RE: Grantline 220 Large Lot & Small Lot TSM (DD9837) August 14, 2019 Routing

WALKSacramento has reviewed the second revision of Grantline 220 Large Lot & Small Lot TSM (DD9837) routed on August 14, 2019. The revised project proposes to develop 126.4 acres as an active adult community with 606 single family units, a clubhouse/recreation center, a neighborhood green park and private streets. The project also proposes 338 high density residential units on two parcels, plus sites for a fire station site, a regional town center and a water quality basin. This revision has approximately 5% more residential units than the original project.

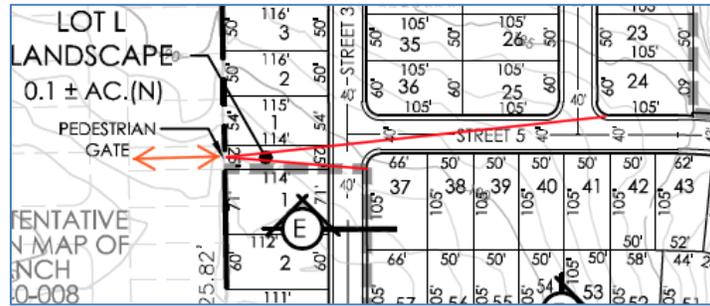
SunCreek Specific Policy C 7. The SunCreek Plan Area shall provide on-street bike lanes along all connector roadways and on local and major roadways.

Whereas the December 2018 and June 2019 plans for Grantline 220 had bike lanes on all connector roadways and major roadways, the August 2019 plans do not include bike lanes on any of the collector roadways.

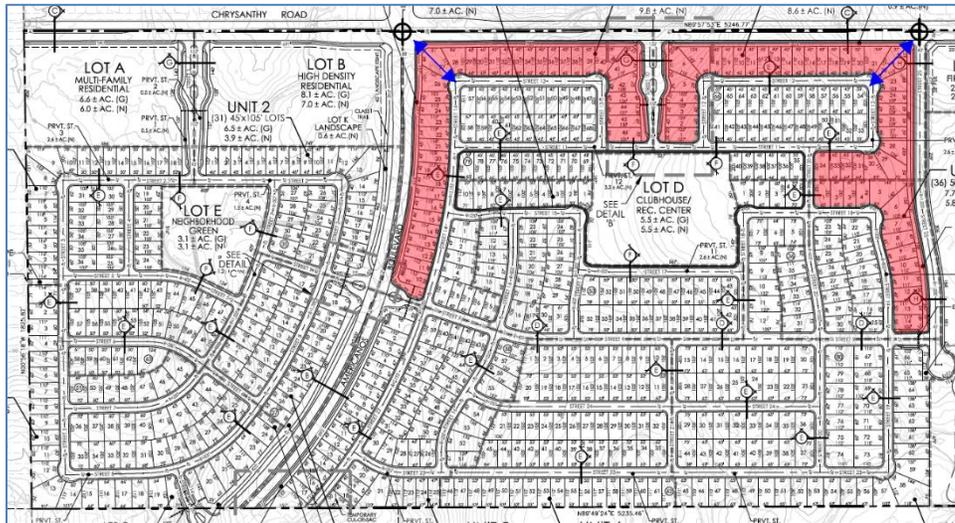
SunCreek Development Regulations DS 2. The neighborhood street system shall be designed to provide multiple, direct and convenient traffic routes that make it easy to walk or bike to nearby homes, parks, schools and commercial areas.

The few connections between neighborhoods will not make it easy for many residents to walk or bike to places other those within their immediate neighborhood.
